THRUSH AIRCRAFT, INC.

SERVICE LETTER

No. SL-AG-113

Flap Light Nuts Rubbing Flaps

Figure 113-2: Nuts on Trailing Edge of Flap Cove

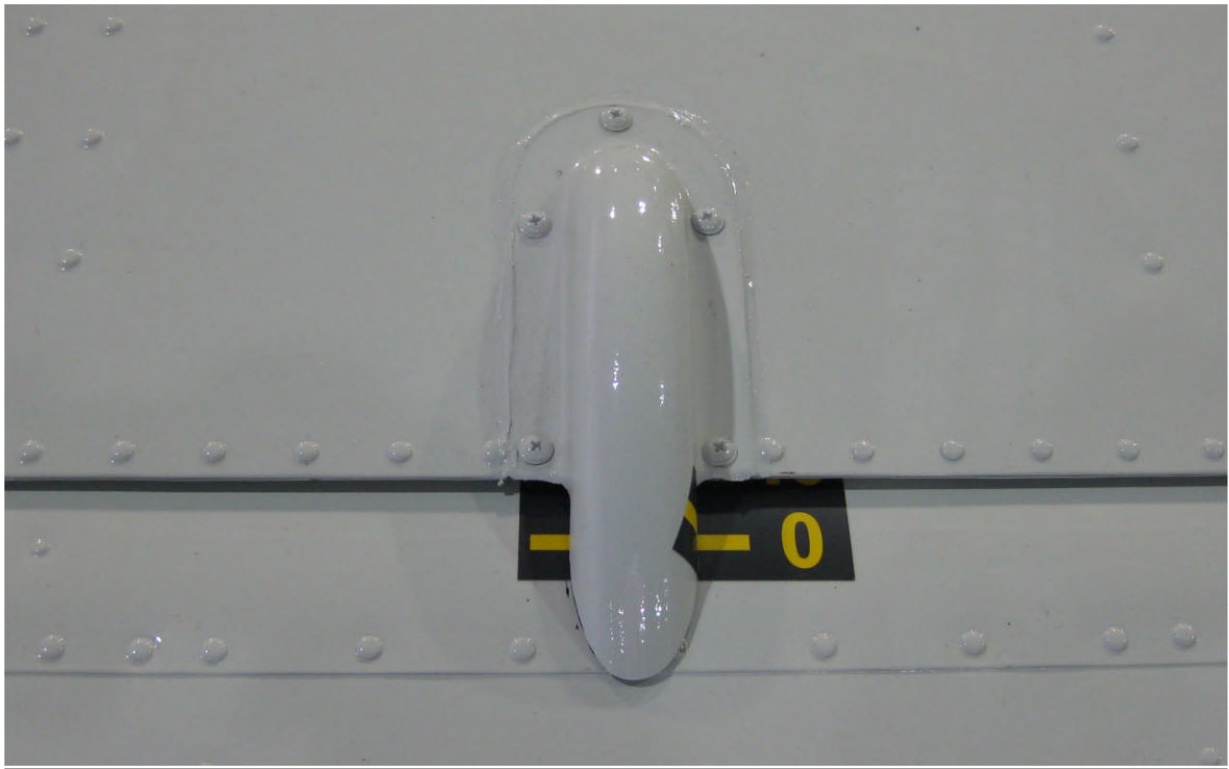
The light that illuminates the wing flap position markings on the left wing is attached to the wing with 5 screws and nuts, as well as sealer to keep rain out. The two aft-most screws are through the flap cove trailing edge and the nut protrudes down approximately one-fourth inch on the under side.

Due to manufacturing variation, the nuts occasionally contact the flap nose skin, causing scratches when the flap moves. This problem is solved before new airplanes leave the factory, but it can happen in service as the airplane accumulates flight hours.

If scratches are found, the two aft attach screws and nuts holding the Flap Light to the wing (see Figure 113-2) need to be changed or modified to eliminate the interference with the flap. There are several ways to remedy this problem:

- The easiest method is to replace the two aft screws with AN526-632-5 screws and replace the AN365-632 nuts with AN364-632 nuts. These are accessible with the flap in the down position. If slightly more clearance is needed, the AN960-6 washers can be replaced with AN960-6L washers, or the washers can be deleted.

- If this does not provide sufficient clearance, the direction of the screw should be reversed; that is, it should be installed from the bottom.
- If neither of these methods provides sufficient clearance, the aft two screws and nuts attaching the flap light assembly to the wing can be left out entirely. The remaining three fasteners are more than sufficient to hold the flap light securely in position. In this case the bead of sealant around the flap light cover should be inspected at every 100 hour inspection to be sure it is intact. If the sealant cracks or separates, remove the old sealant and replace with new sealant. Fuel tank sealant is used at the factory.
